DATE: March 27, 2026

PROJECT: Family Health Services of Darke County
POD 3 Interior Renovation

PROJECT ADDRESS: 5735 Meeker Road
Greenville, OH 45331

ADDENDUM NO. 1

E4 DEMOLITION FLOOR PLAN POD 3
1/8" = 1'-0"

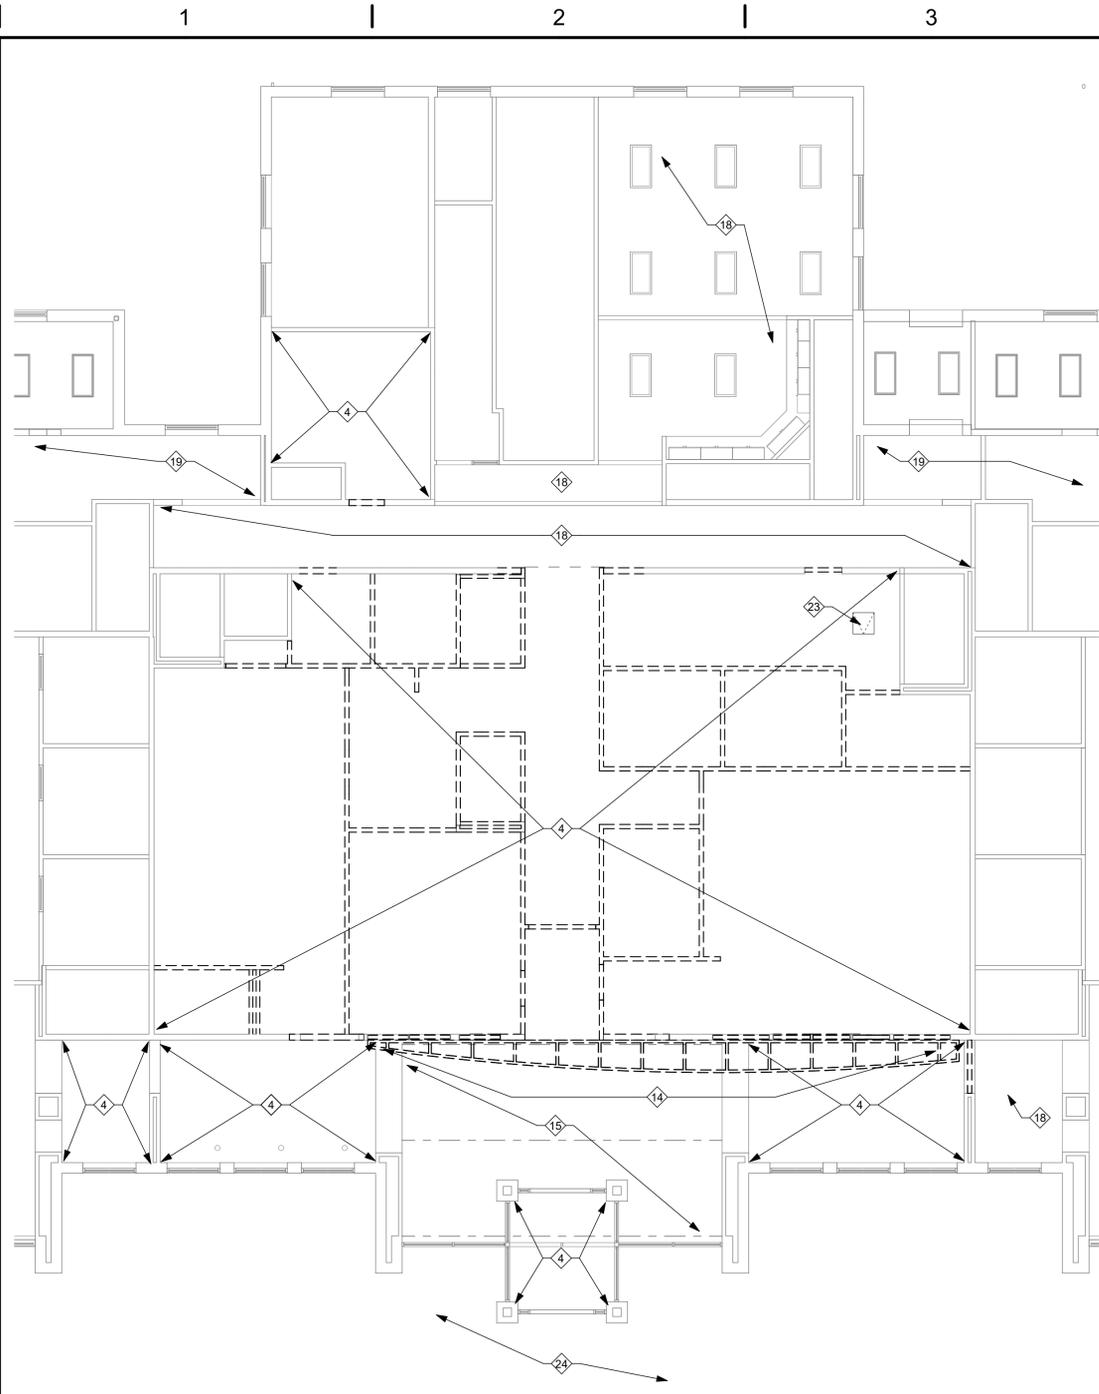
- ITEM A1 Drawing Sheet A0.3 DOOR FRAME AND WINDOW SCHEDULE
REVISE opening W138
- ITEM A2 Drawing Sheet A1.1 DEMOLITION FLOOR PLAN
ADD CONSTRUCTION NOTE #9 to opening W134
- ITEM A3 Drawing Sheet A1.2 REFERENCE PLAN
REVISE Detail E1/A1.2 ENLARGED NEW WORK PLAN
Details and Dimensions @ Nurses Table

- b. **Q.** Note 8 on page A7.1 calls for a contractor furnished & installed toilet paper dispenser, note 6 on page A1.1 calls for existing toilet paper dispensers to be salvaged & reused? .

A. Three Restrooms are being removed, contractor shall salvage toilet dispensers for reinstallation. If additional toilet paper dispensers are required they will be Owner Furnished, Contractor Installed. (Note 8 (A7.1/A7.2/A7.3) is updated.

C2 HEADER ELEVATION
1" = 1'-0"

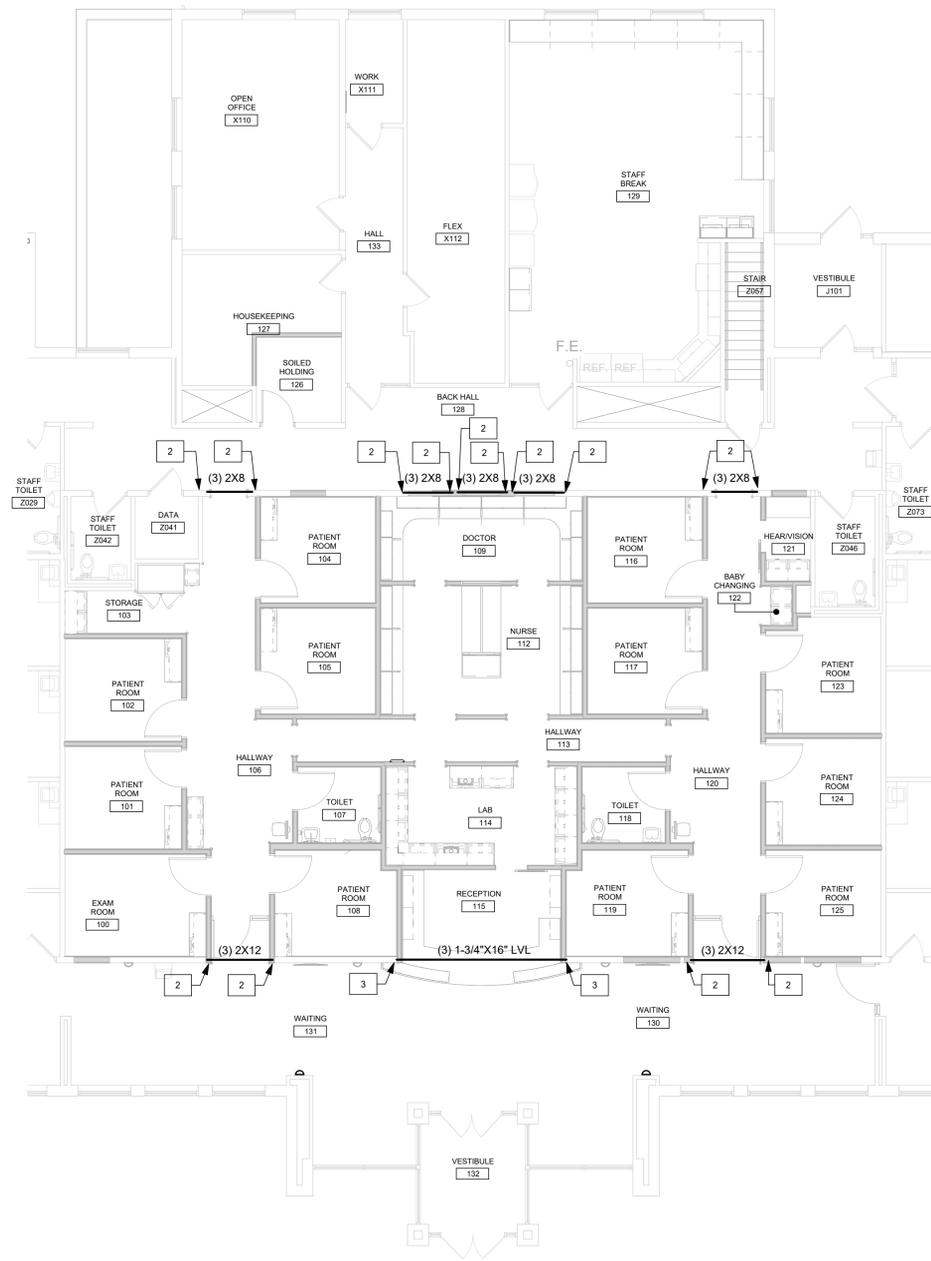
- ITEM A4 Drawing Sheet A1.4 STRUCTURAL PLAN & DETAILS
ADD NOTE @ Detail C2/A1.4 HEADER ELEVATION
- ITEM A5 Drawing Sheet A7.1 INTERIOR ELEVATIONS
REVISE CONSTRUCTION NOTES (Sheet A7.1, A7.2, A7.3)
REVISE Elevations B4/A7.1 & B5/A7.1
- ITEM A6 Drawing Sheet A7.2 INTERIOR ELEVATIONS
REVISE CONSTRUCTION NOTES (Sheet A7.1, A7.2, A7.3)
REVISE Elevations E3/A7.2, E5/A7.2, F1/A7.2 & F3/A7.2
- ITEM A7 Drawing Sheet A7.3 INTERIOR ELEVATIONS
REVISE CONSTRUCTION NOTES (Sheet A7.1, A7.2, A7.3)
REVISE Elevations D1/A7.3, E2/A7.3
- ITEM A8 Drawing Sheet A8.1 CASEWORK DETAILS
REVISE Details: A1/A8.1, B2/A8.1 & D6/A8.1
